Access Compliance Report Public Rights-of-Way (Curb Ramps)

Main Street: TANDEO_DR Cross Street: AIROSO_ST Location: NE

ADA ID: RPRK211119123233 Ramp Type: Type 1 - Perpendicular Diagonal Initial Pass/Fail: Fail Overall Compliance: No Severity Score: 2

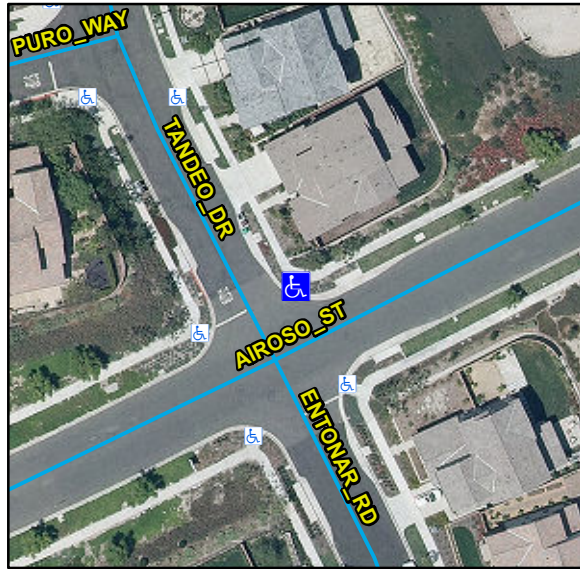
R304.2.2, R304.5.3, STD 1115

Remove & Replace Curb Ramp With Two New Directional Ramps or Equivalent.
